MIL-D-48350 (PA)
Amendment 3
16 June 1975
Superseding
Amendment 2
11 February 1975

DISPENSER CONTROL PANEL
FOR
M56/XM58 MINES/MARKERS

This Amendment forms a part of Military Specification MIL-D-48350 (PA) dated 15 April 1974 and is approved for use by all Departments and Agencies of the Department of Defense.

TEST CIRCUIT NO. 1

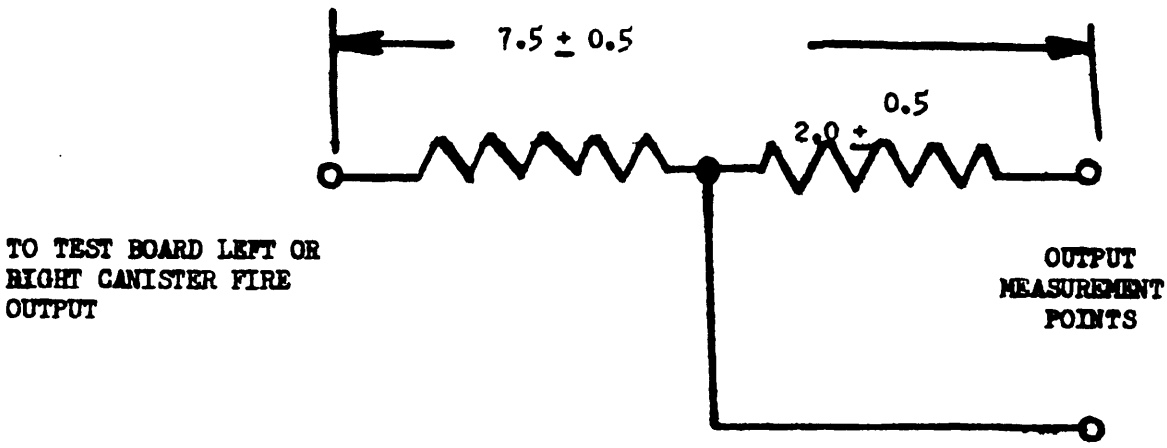
Paragraph 4.4.6, Test No. 3, Step C, delete the last 2 sentences and substitute:

“Solenoid outputs shall be measured using Test Circuit No. 1 of this specification. Canister outputs shall be measured using Test Circuit No. 2 of this specification.”

CURVE A
MINES - PAIRS

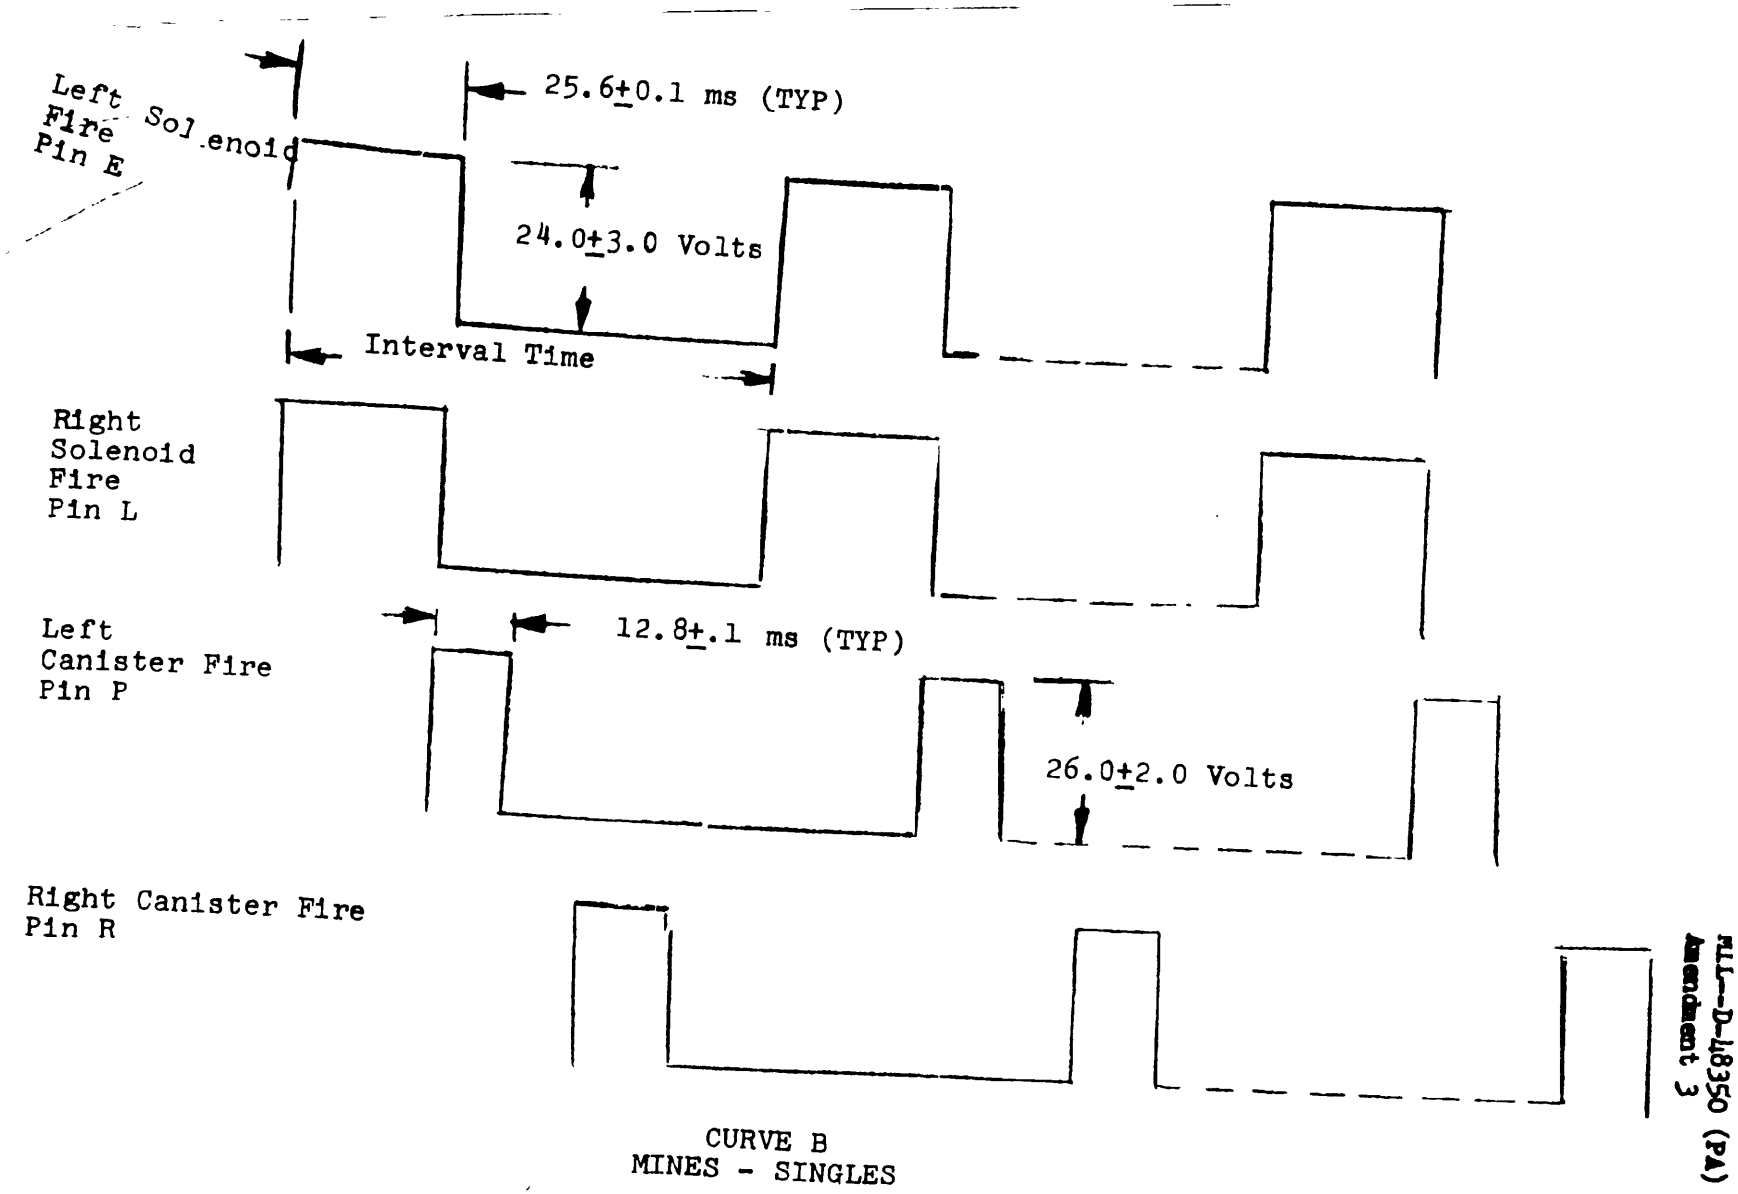
*Page 22, Curve A delete and replace with new Curve A

CURVE B
MINES - SINGLES

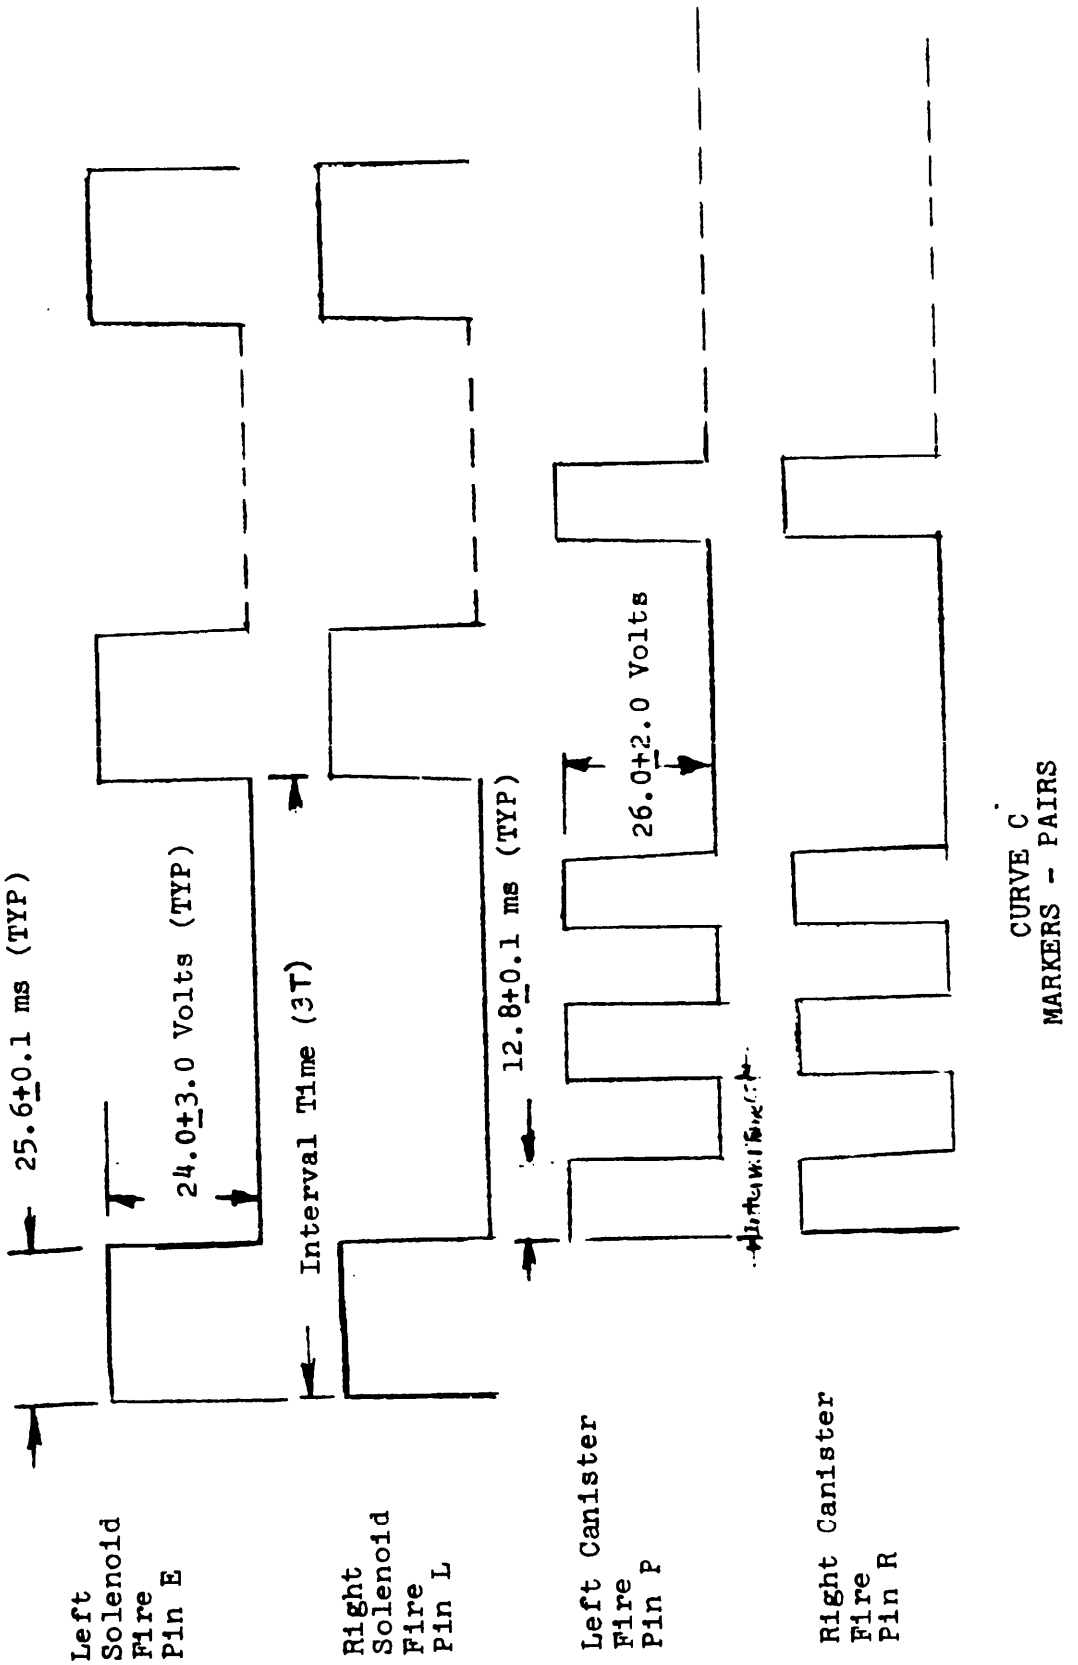
*Page 23, Curve B delete and replace with new Curve B

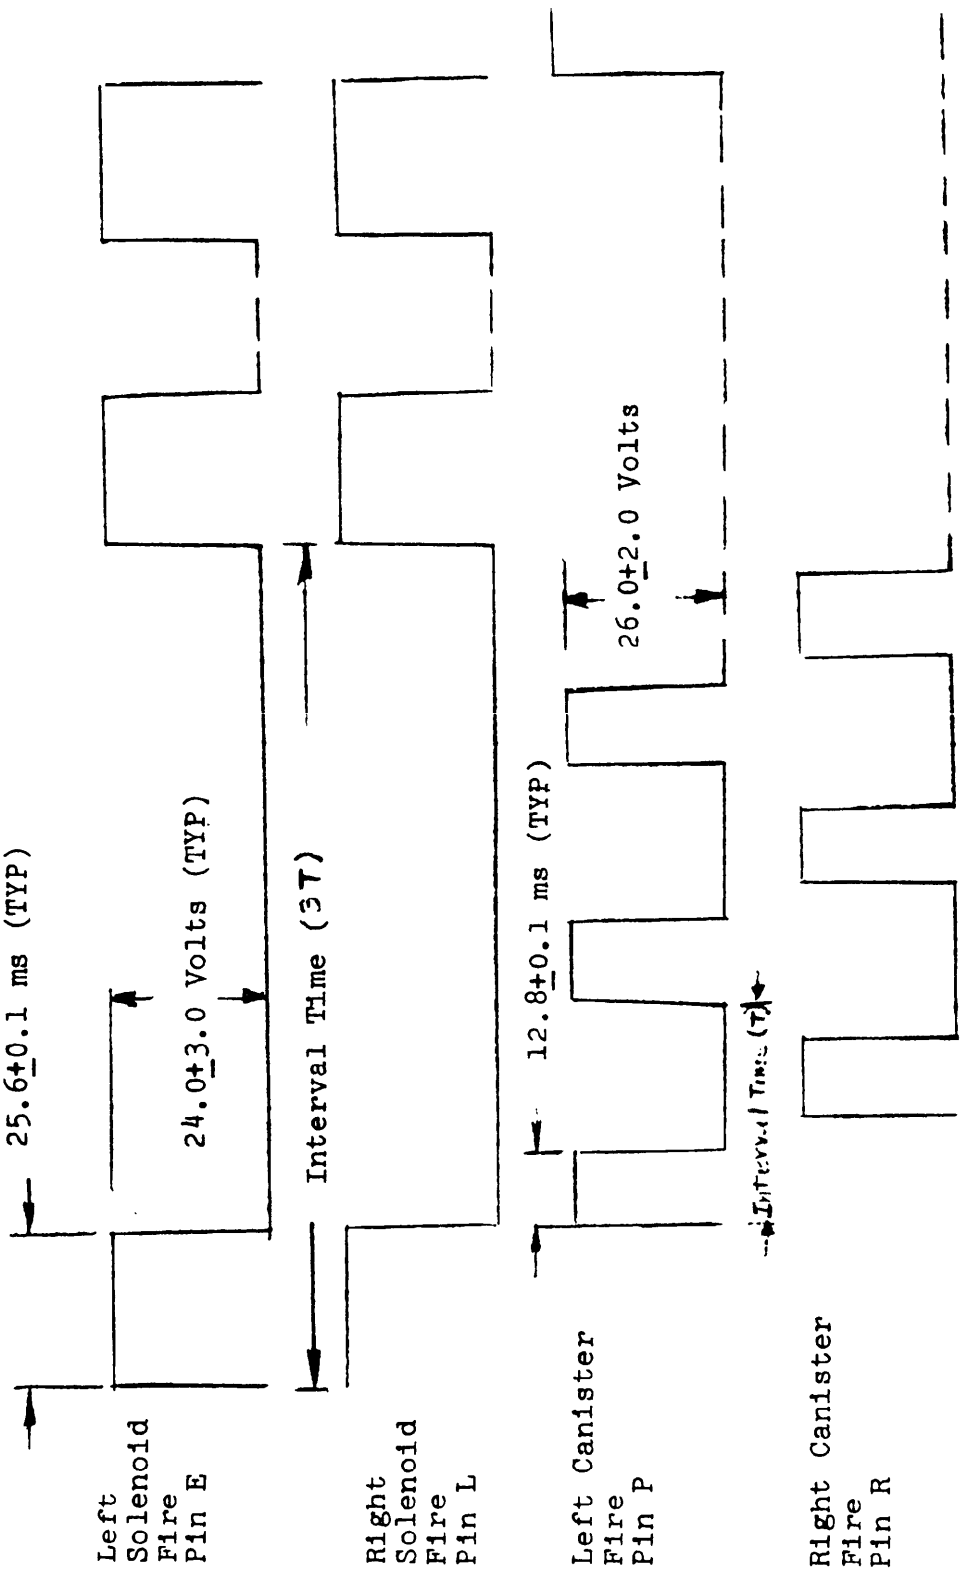
*Page 24, Curve C delete and replace with new Curve C
